## TUALATIN CITY PLANNING COMMISSION MEETING

THURSDAY, JANUARY 21, 2021

1. The Tualatin Planning Commission is asked to provide a recommendation to the City Council on adopting an updated Stormwater Master Plan for the City of Tualatin and updating Comprehensive Plan policies and relevant Development Code references to reflect the updated plan (Plan Text Amendment PTA 21-0001).

Exhibit 5 – Public Comments on Stormwater Master Plan 12-7-20 through 1-10-21

**Figure 2-2  
Project Area Overview**

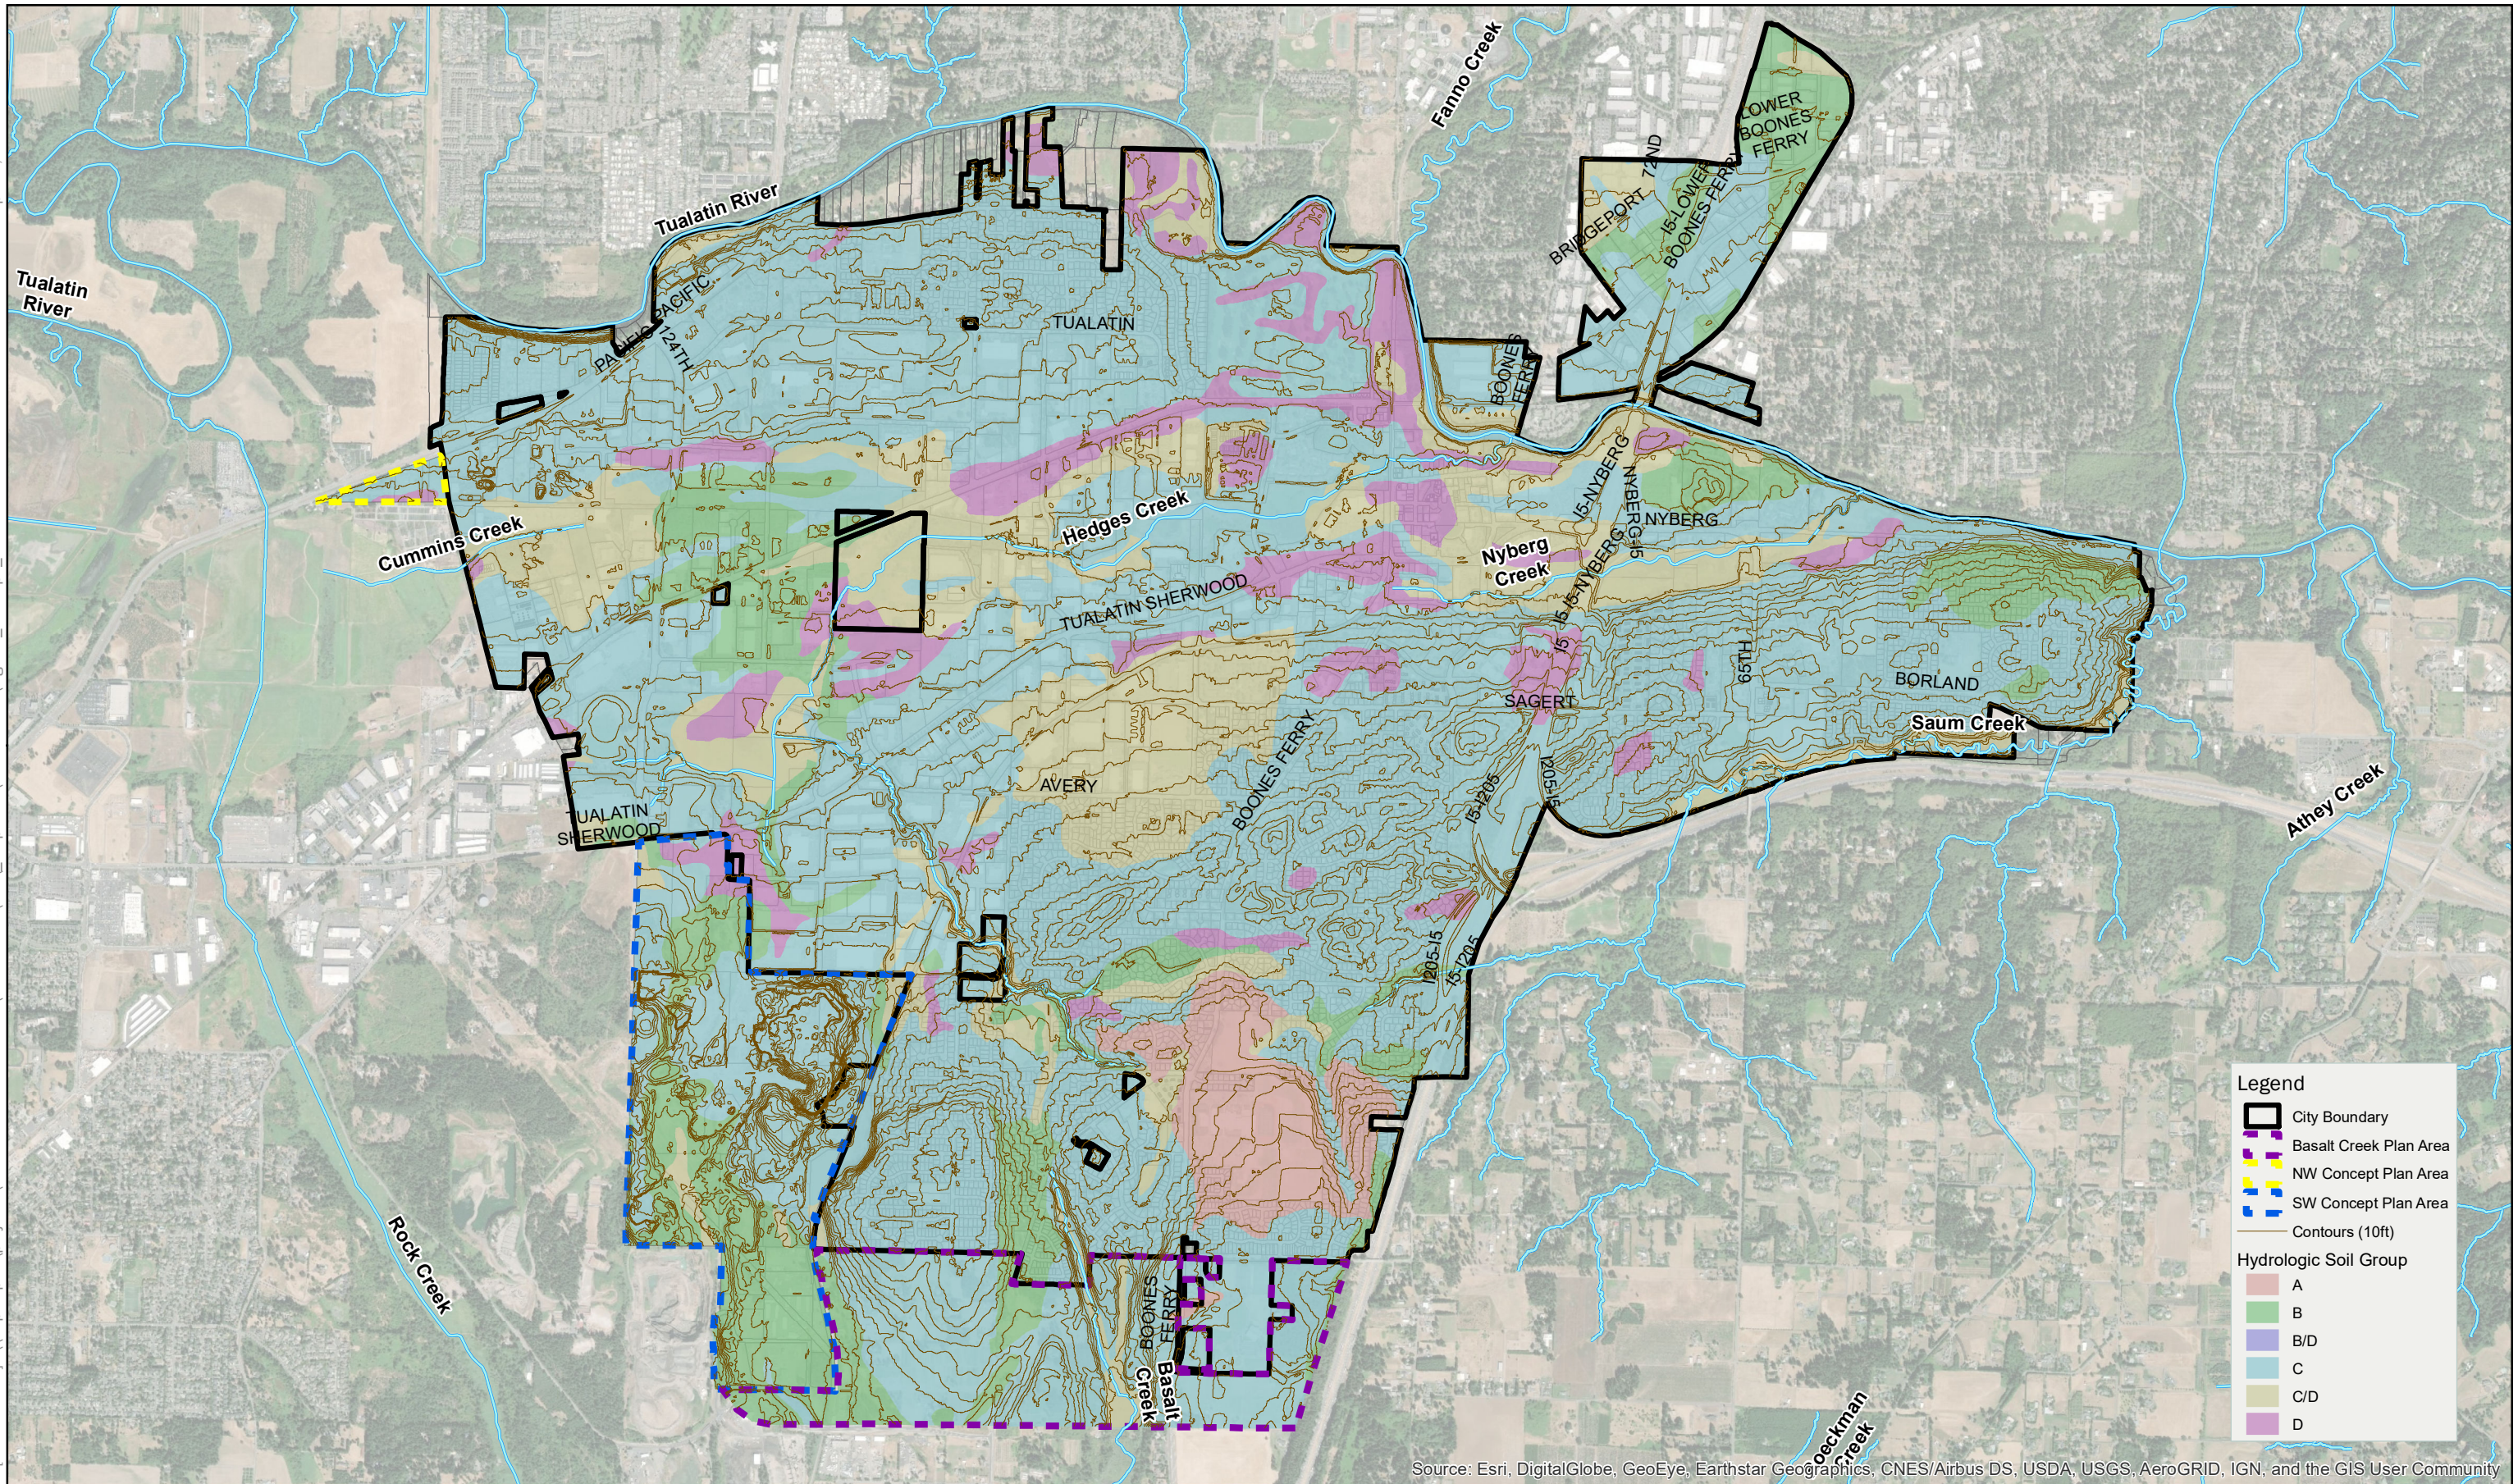
An example of questionable information provided within many maps within the proposed Stormwater Management Plan for the City, is **Figure 2-2 Project Area Overview**.

The Legend within Figure 2-2 provides keys as to the location of

This area which contains wetlands and various Natural Resources requiring conservation and protection was identified within the Basalt Creek Concept Plan in which both Cities agreed to have "joint management" of the "Natural Area". It would seem reasonable this information which might impact Land Use Planning within the Basalt Creek Area and is downstream from the Basalt Creek lands already annexed into the City, would be identified on the Figure 2-2 map, and include additional information within the narrative of the proposed Stormwater Management Plan as a potential constraint or limitation in the planning of Stormwater Management in the area or upstream from the "Natural Area".

**Figure 2-3**  
**Topography and Soils**

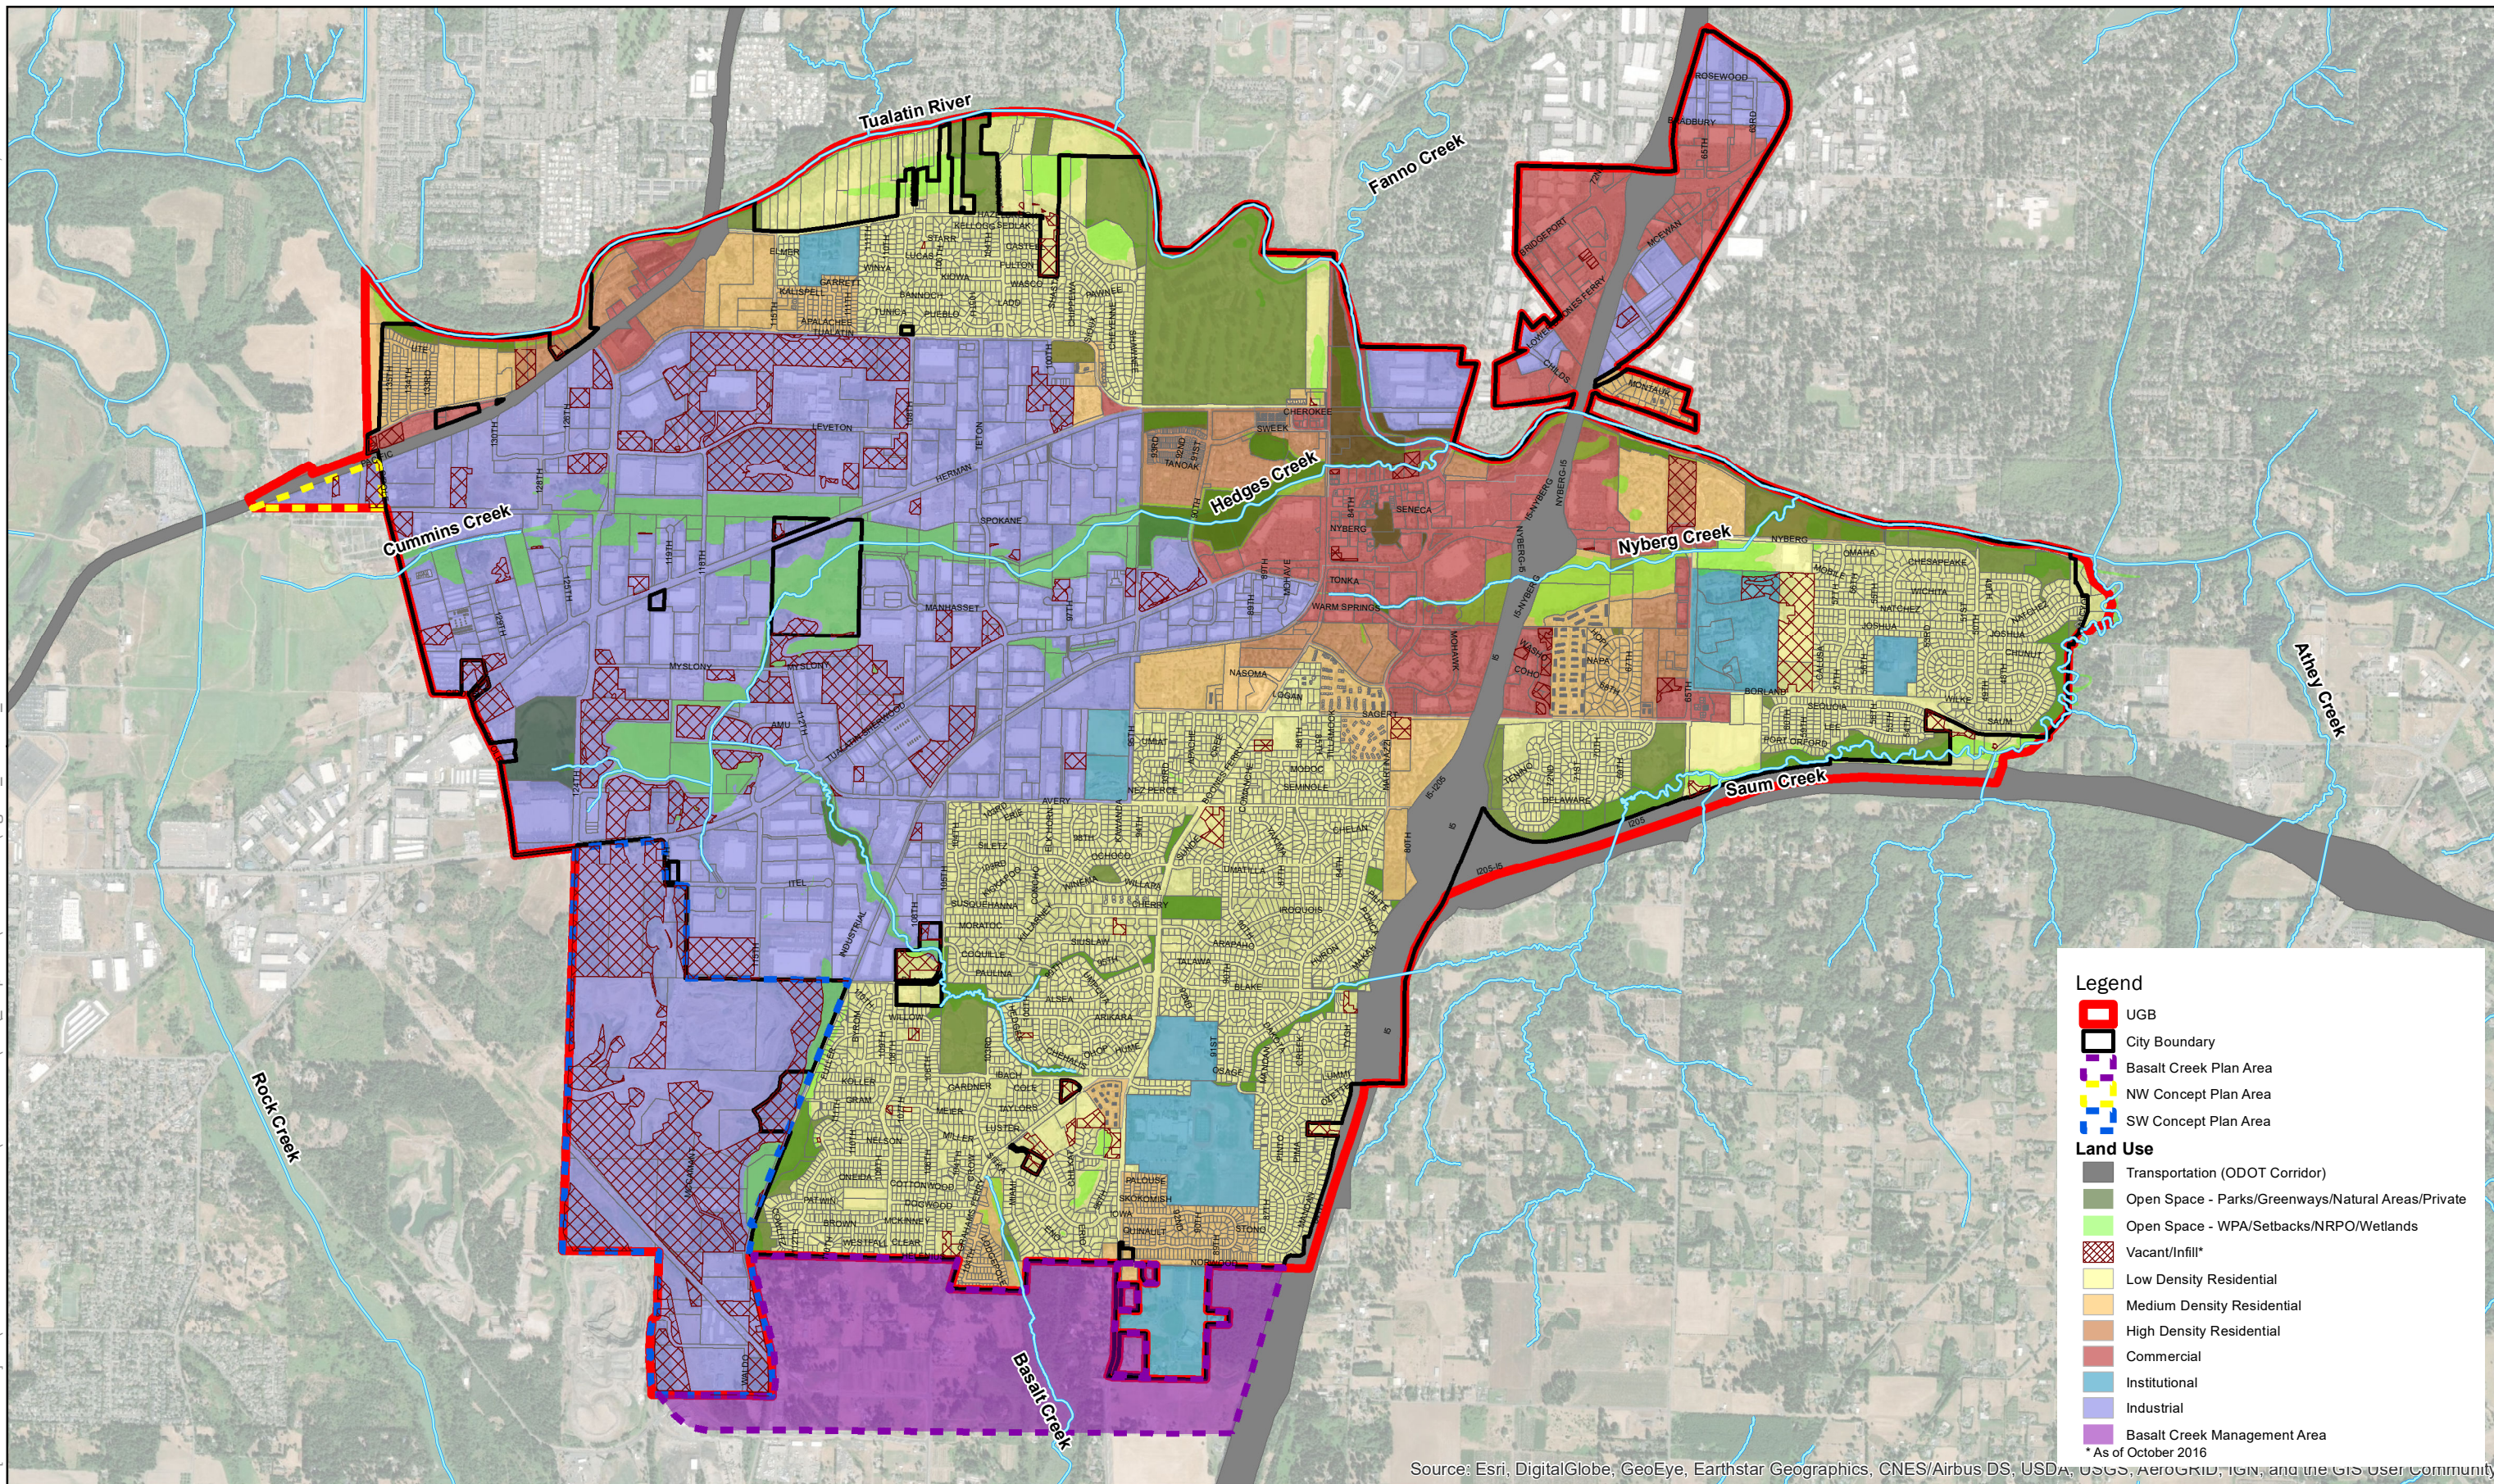
Comment LEA7. SWMP Figure 2-3 - Topography and Soils map contains too many TEXT overlays in the vicinity of Boones Ferry Road South of Norwood Road and the Lucini Property.

Comment LEA8. SWMP Table 2-1 (Page 2-3) in combination with Figure 2-3 - Topography and Soils suggests that infiltration is not a likely future runoff design solution in the BFR south. This is particularly important since this area is perched above steep slopes draining to Basalt Creek. This area is also above drinking water wells in the area including the Lucini property.
